RFT 26-031 Milton # 13 Elementary School and Child Care Facility

PROJECT NO. 22124
HOSSACK & ASSOCIATES ARCHITECTS

ADDENDUM NO. 3

Issued February 24, 2026

SECOND FLOOR LIGHTING PLAN

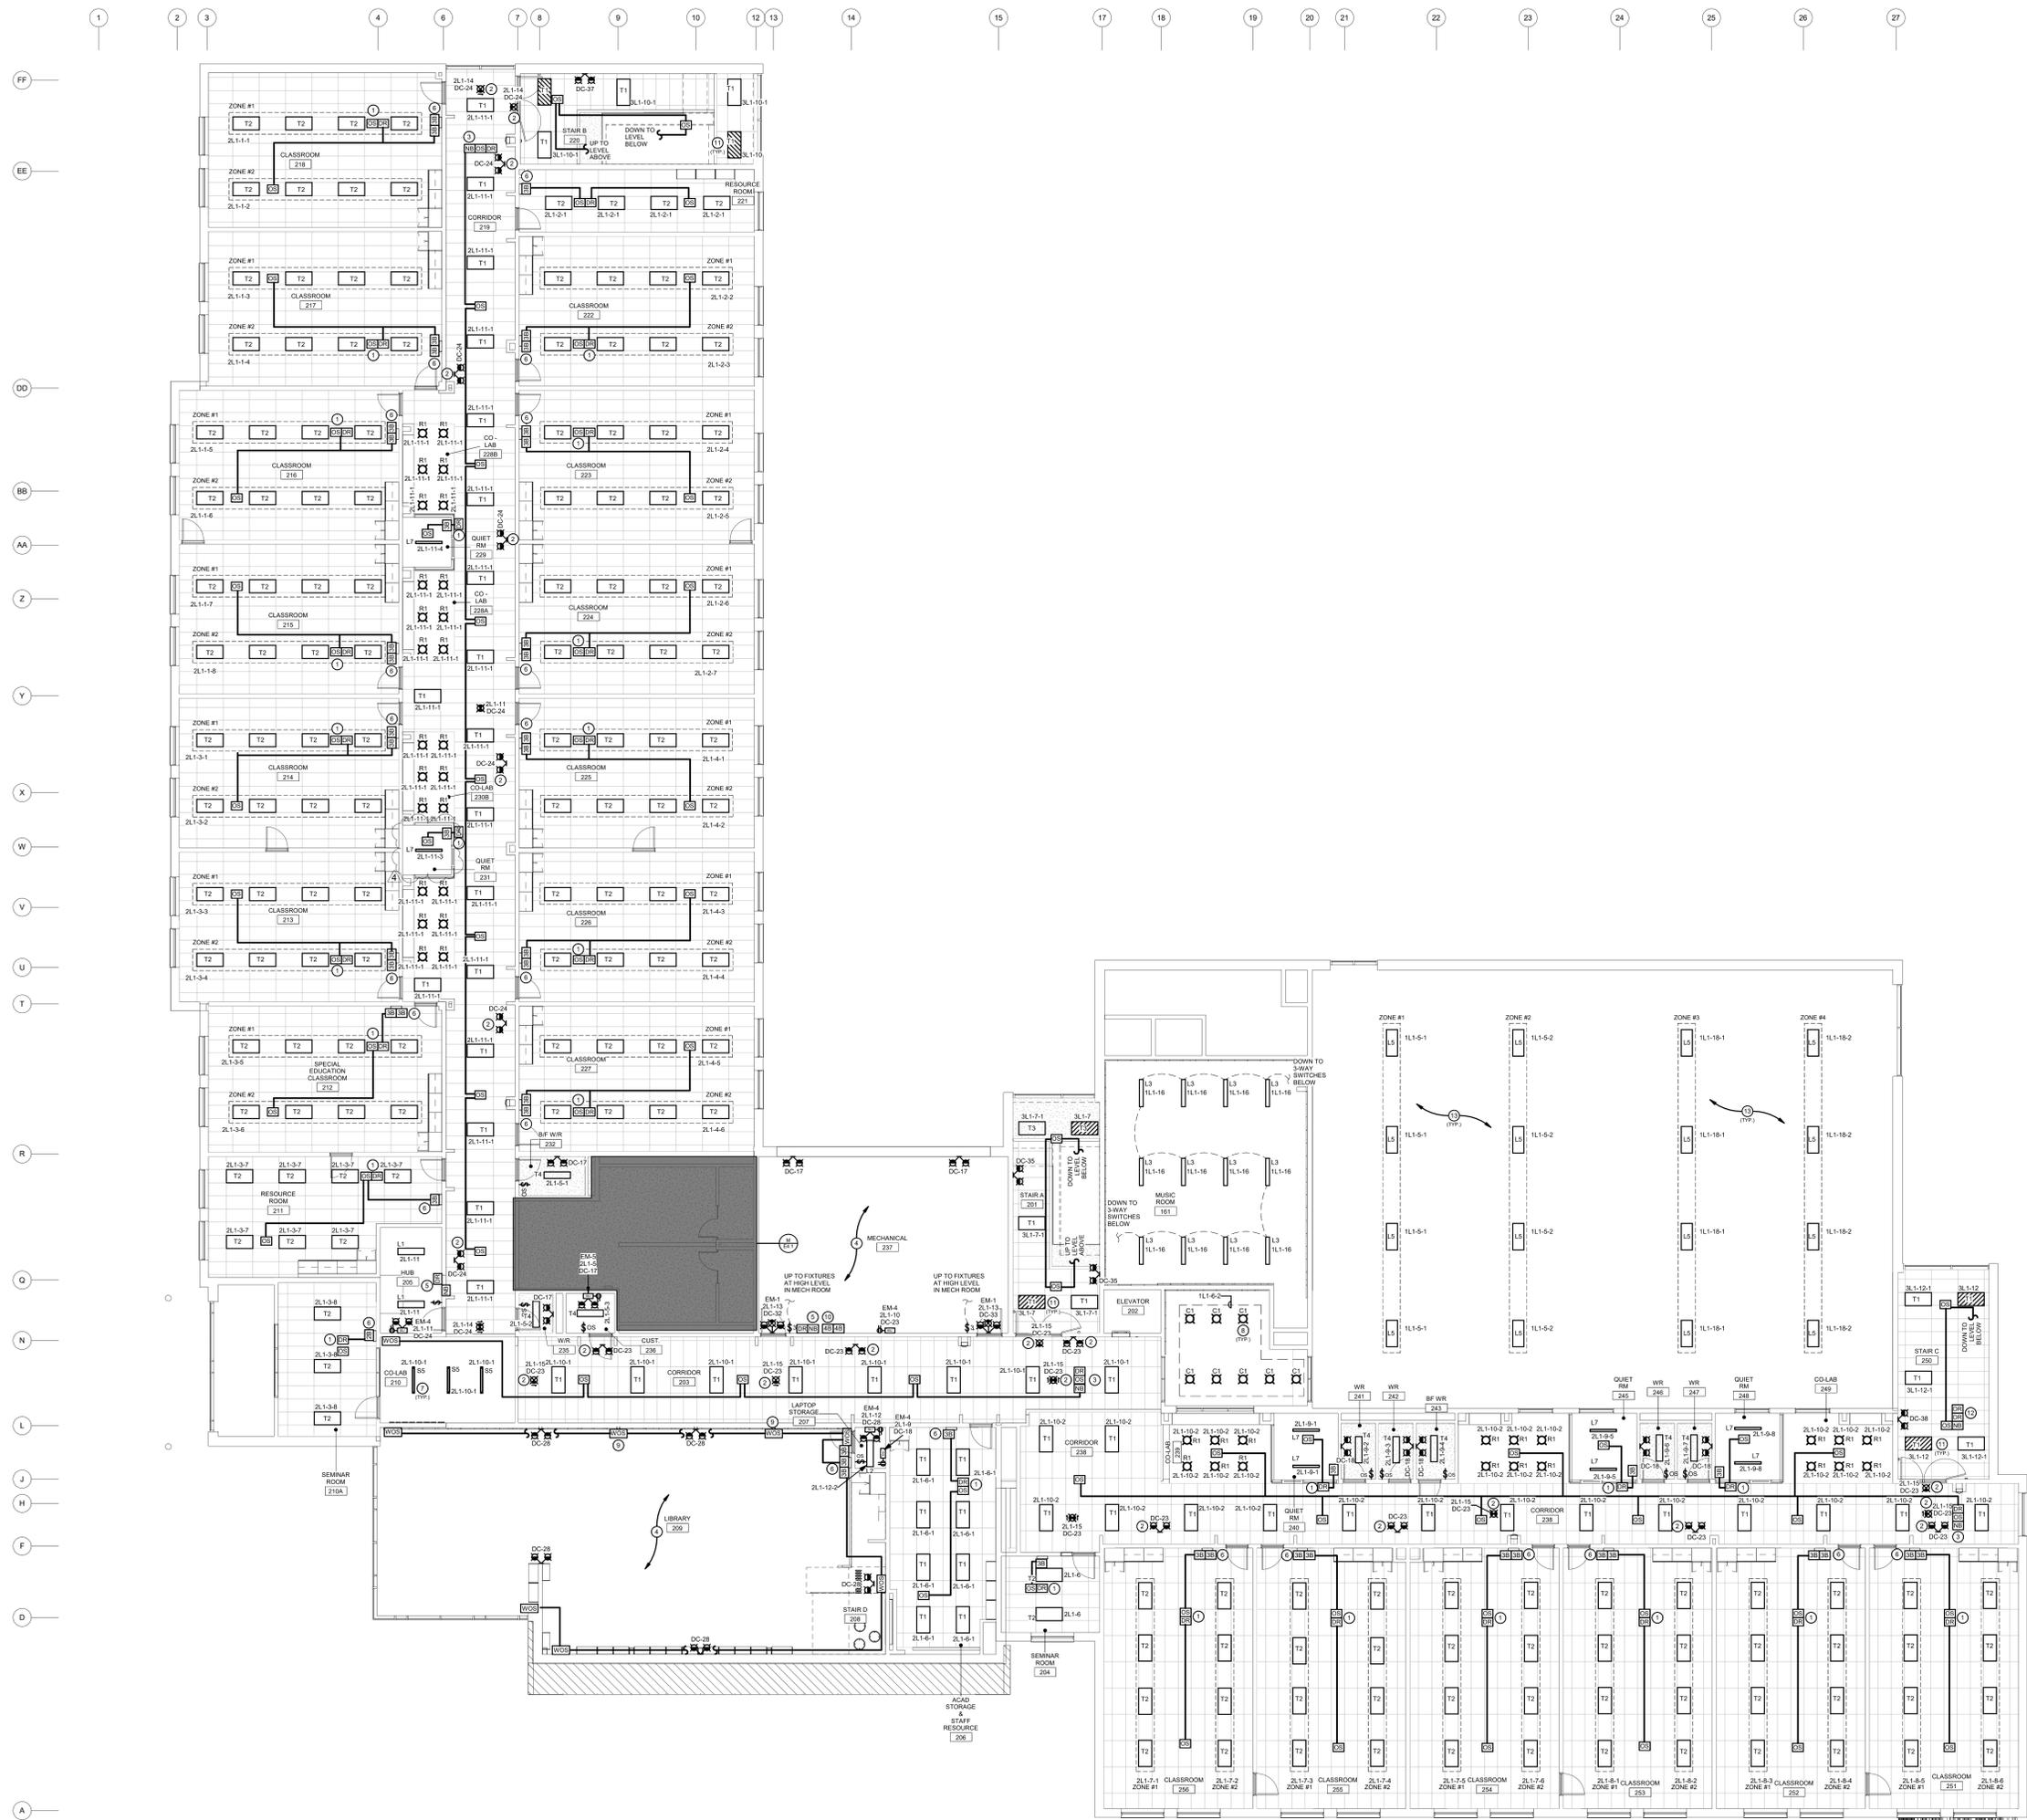
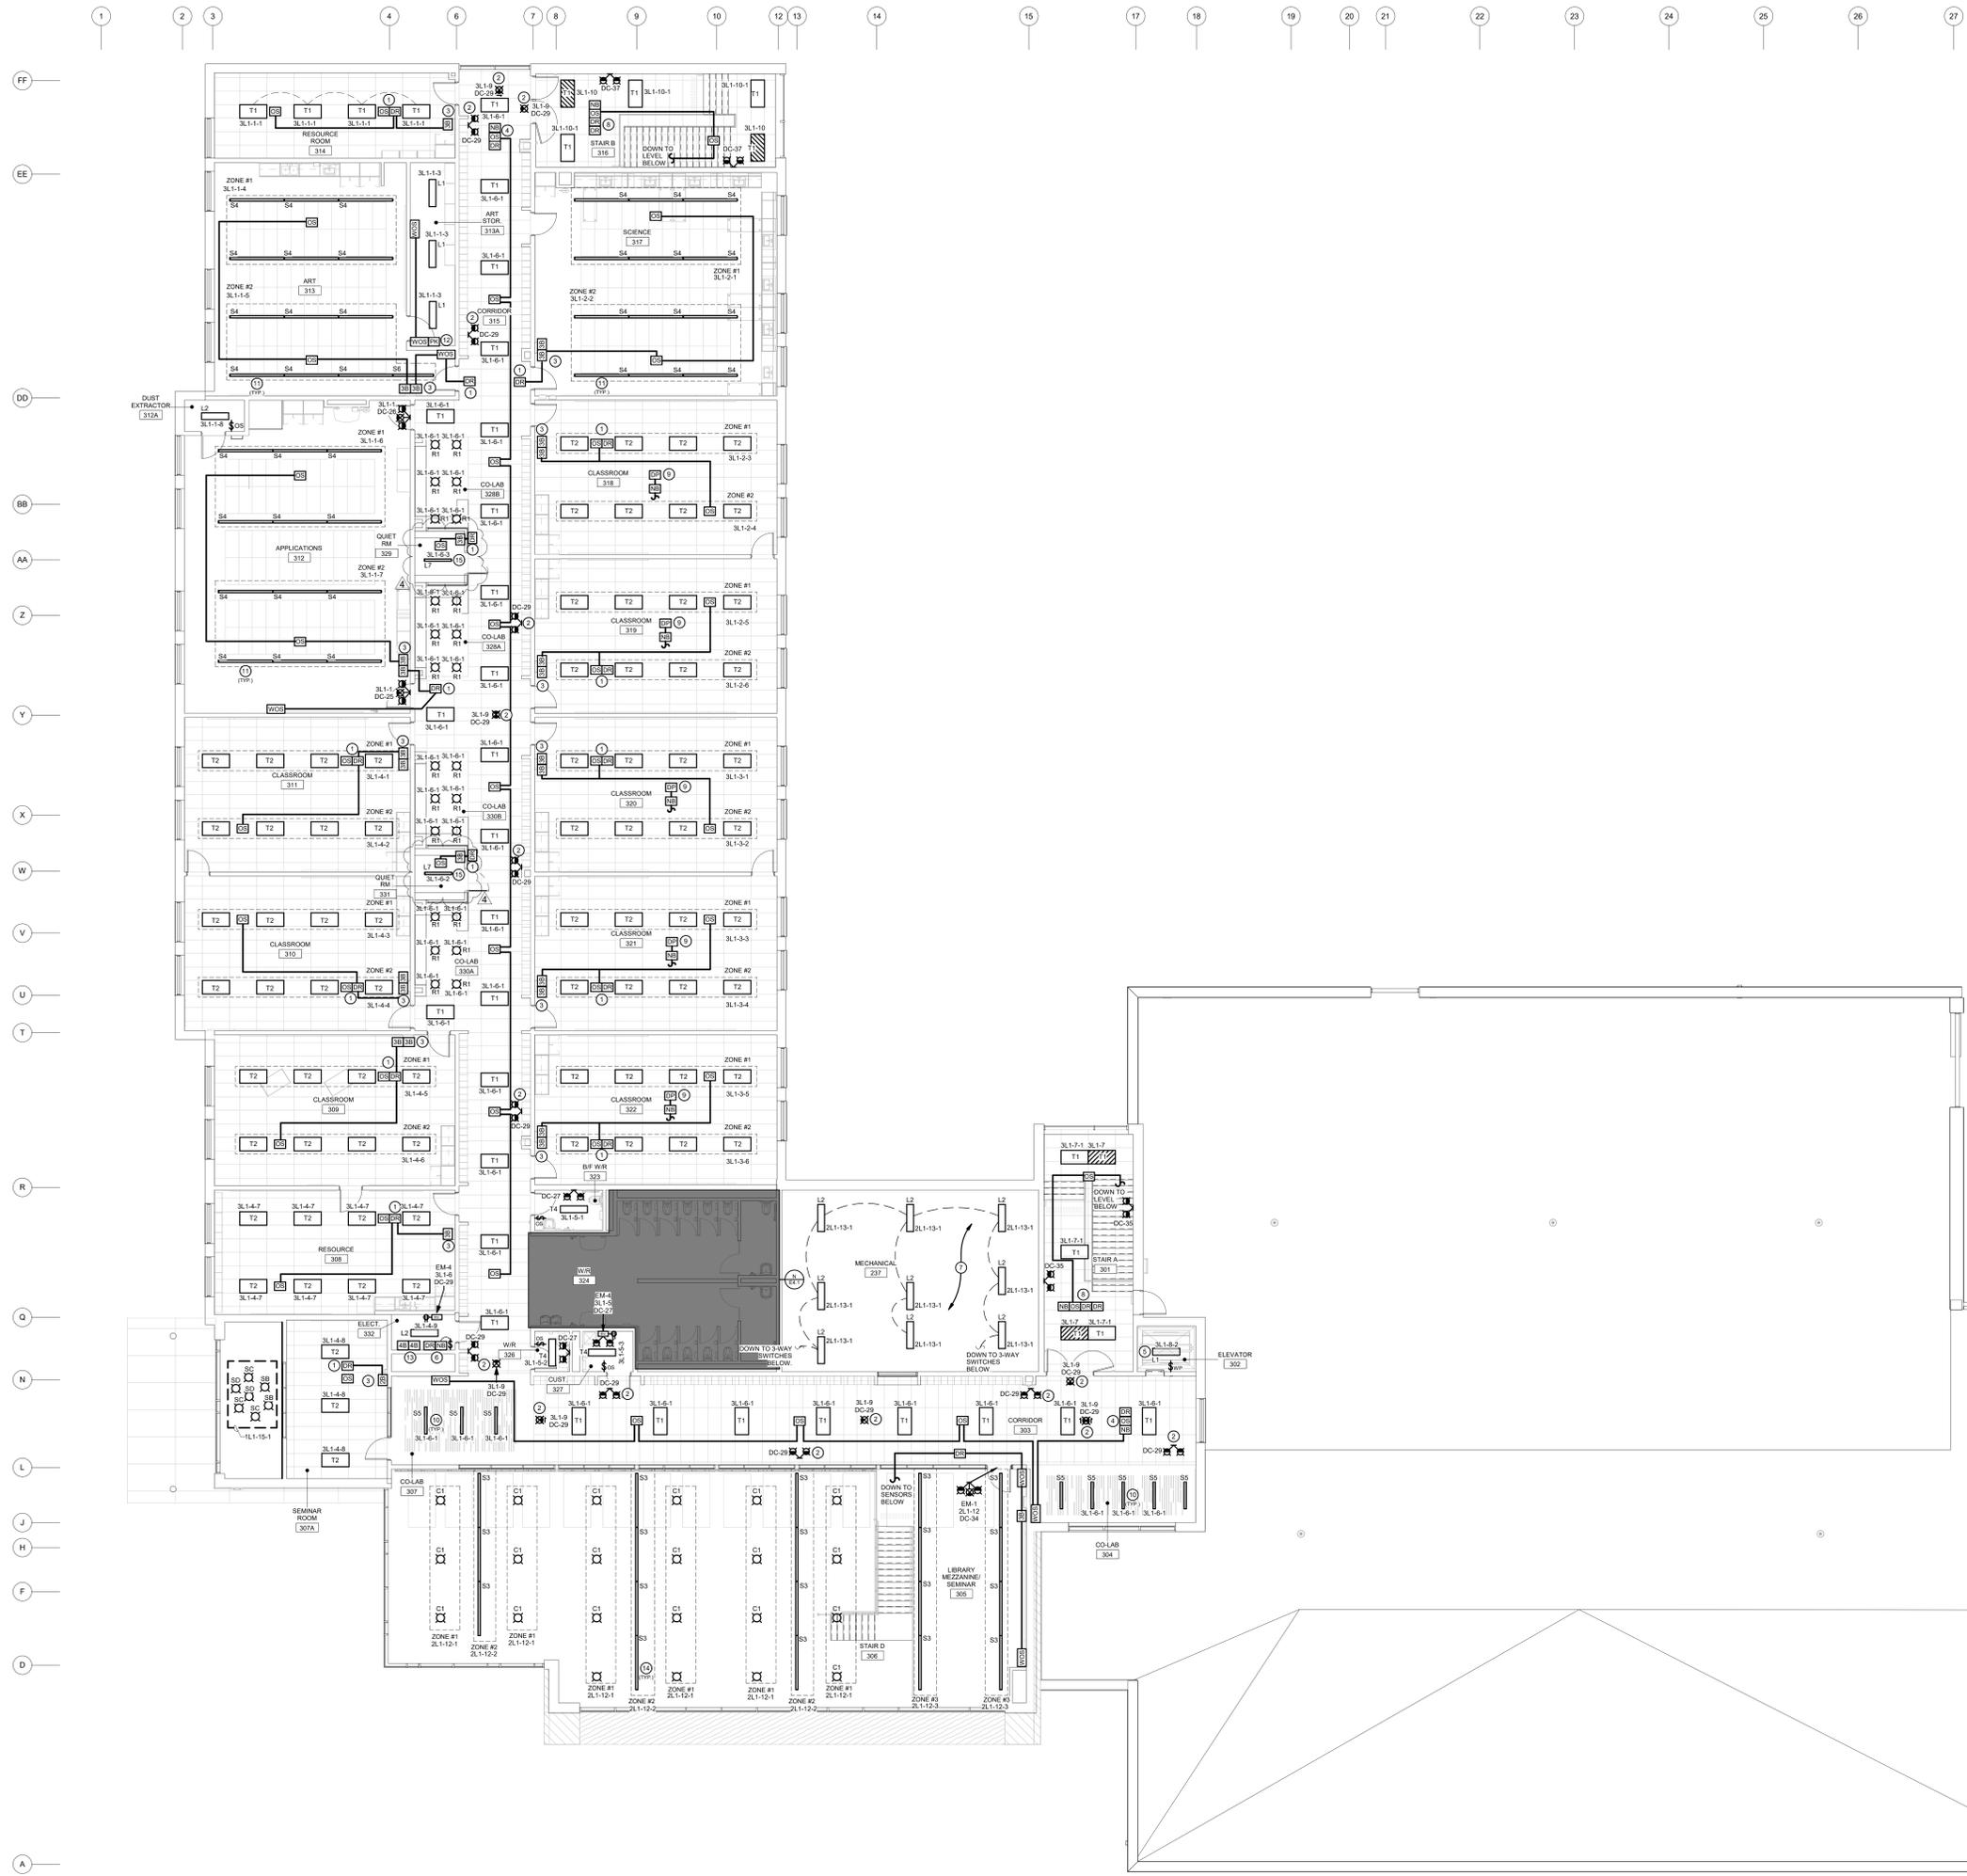
- 2.0 Reference Attached Reissued Drawings E2.2 and E2.3
.1 All quiet room fixtures are to be revised from suspended type 'S1' to recessed type 'L7'.

**THIRD FLOOR
POWER & SYSTEMS
PLAN**

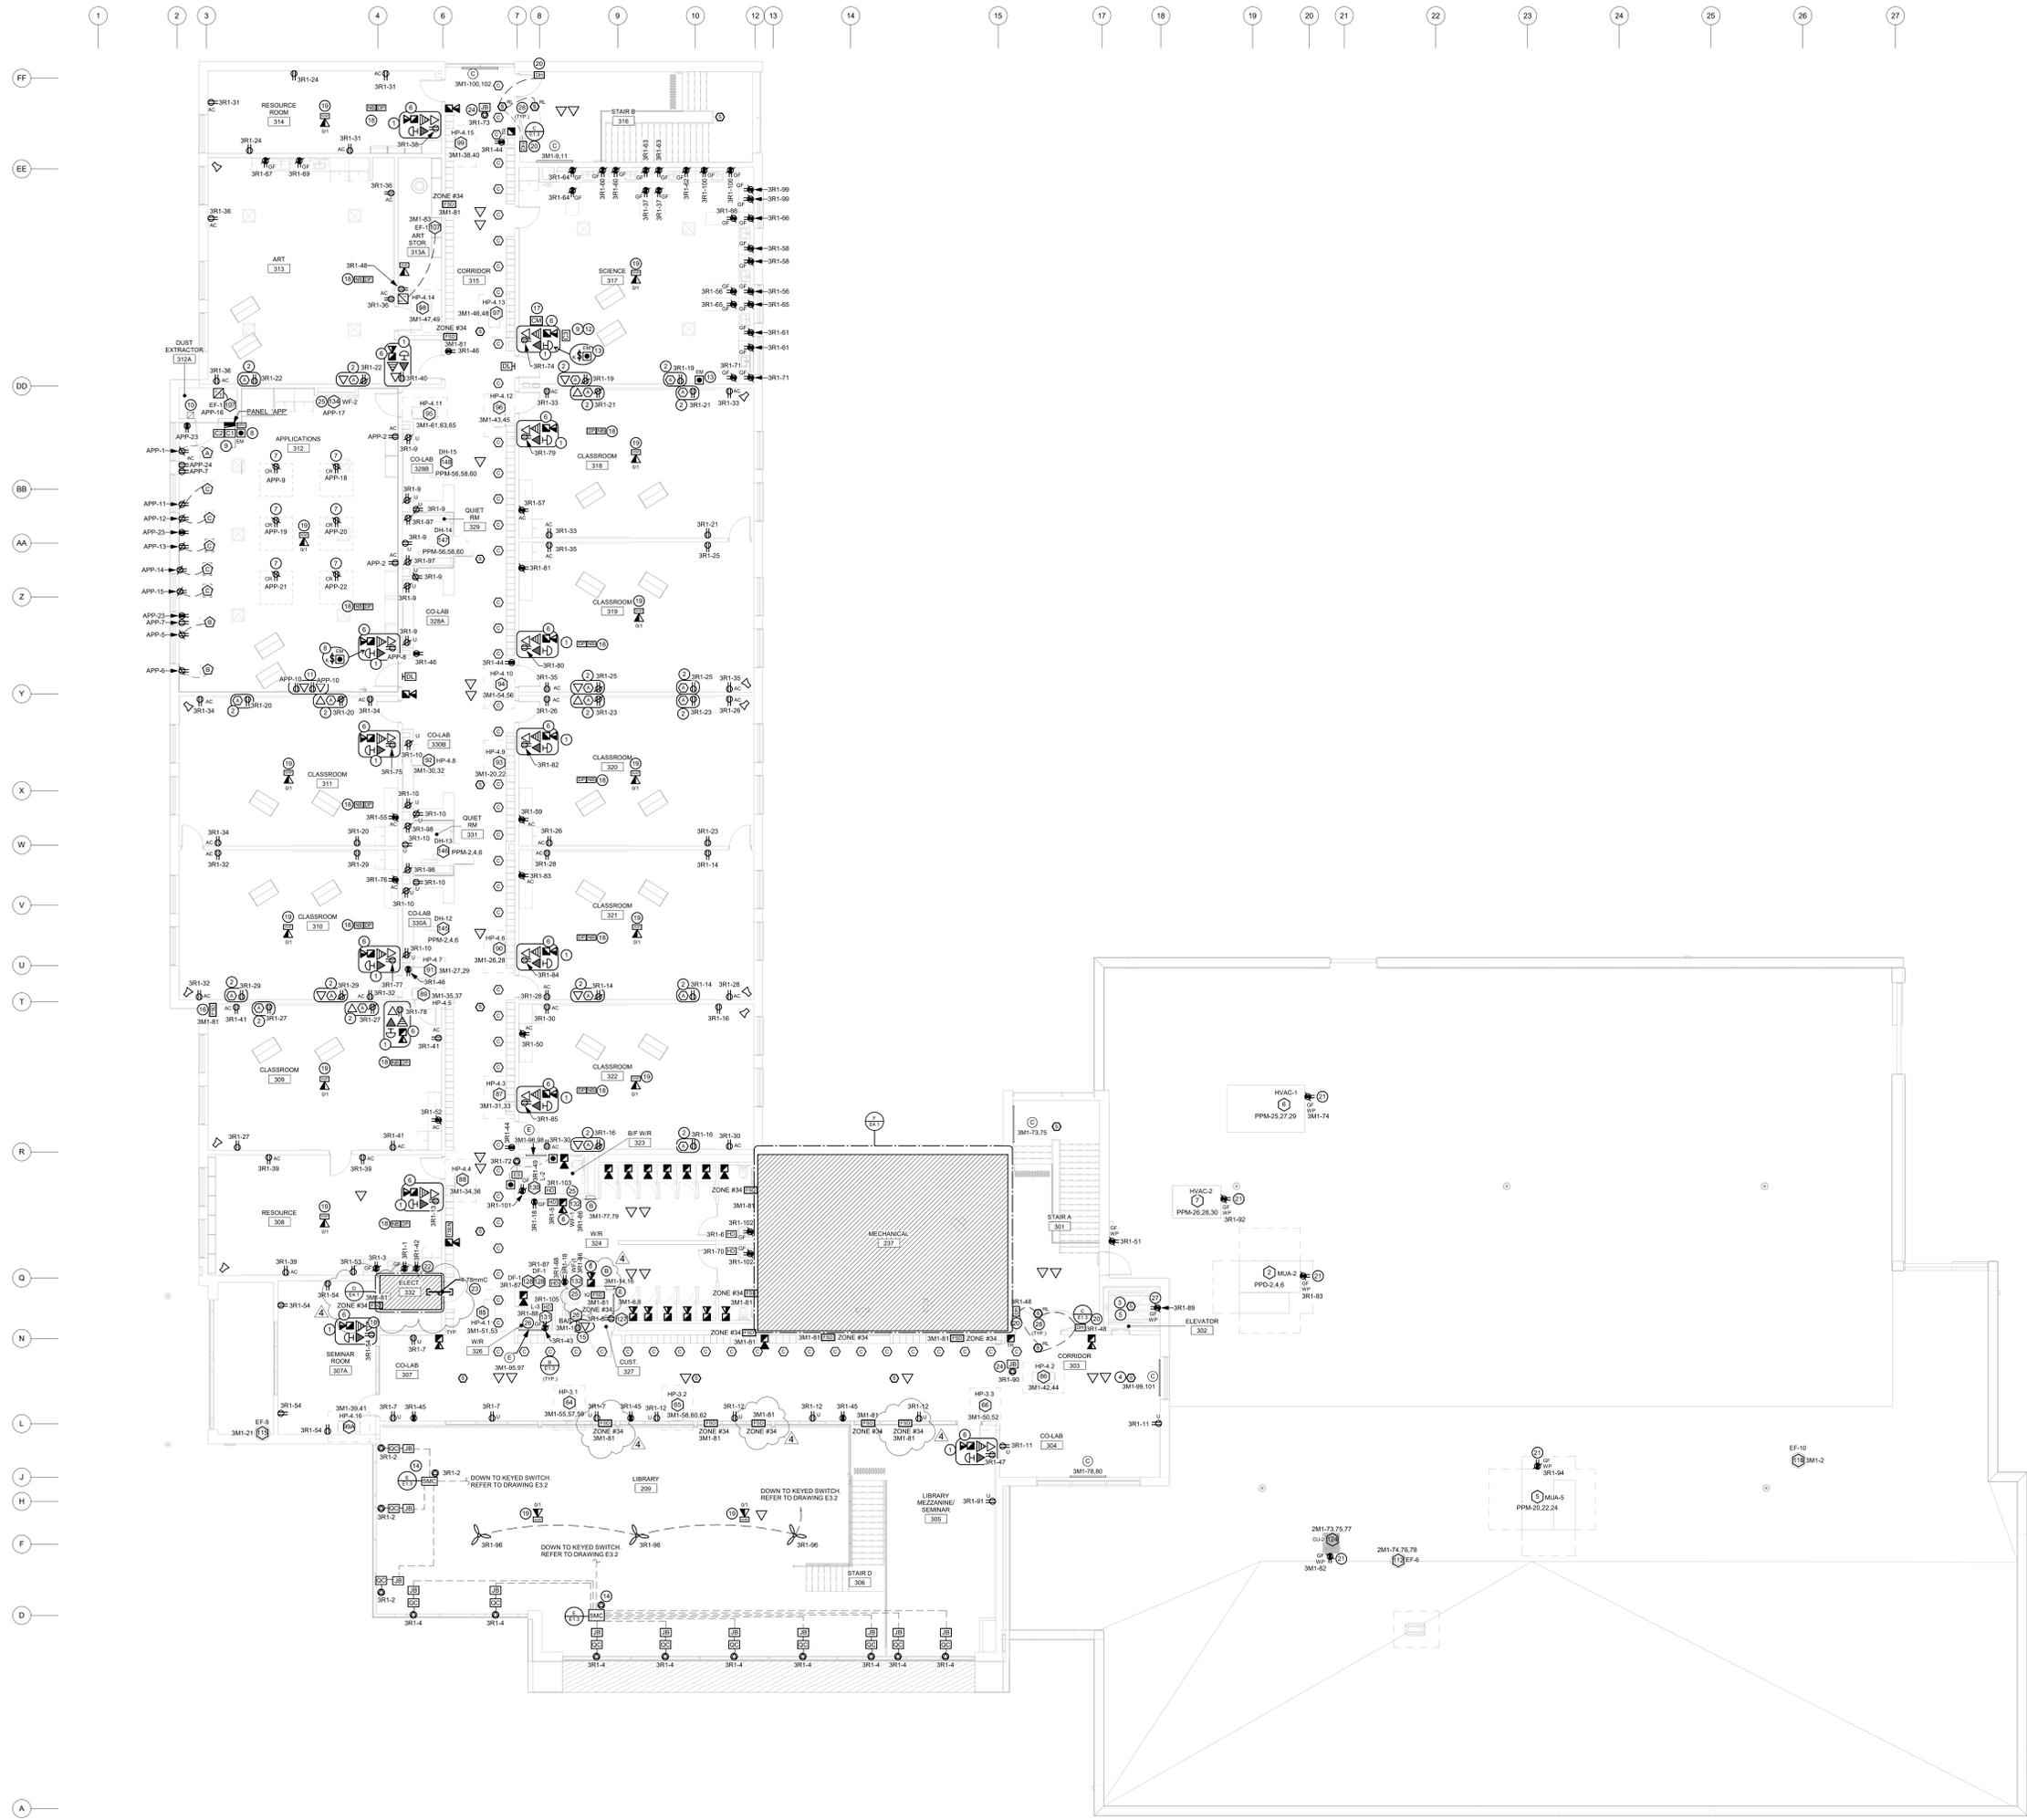
- 3.0 Reference Attached Reissued Drawings E3.1 and E3.3
.1 Revise locations of fire smoke dampers as per attached reissued drawings.
.2 Provide additional fire smoke damper at ceiling space adjacent to Sensory 154. Feed from adjacent fire smoke damper circuit.
.3 Provide new exhaust fan EF-3 adjacent to Laundry 418. Feed from spare 15A-1P breaker within panel '1M2'. Coordinate exact location within mechanical contractor.
.4 Provide additional fire smoke damper at ceiling space adjacent to Cust. 327. Feed from adjacent fire smoke damper circuit.

- .5 Provide three additional fire smoke dampers at ceiling space adjacent to Library 209. Feed from adjacent fire smoke damper circuit.
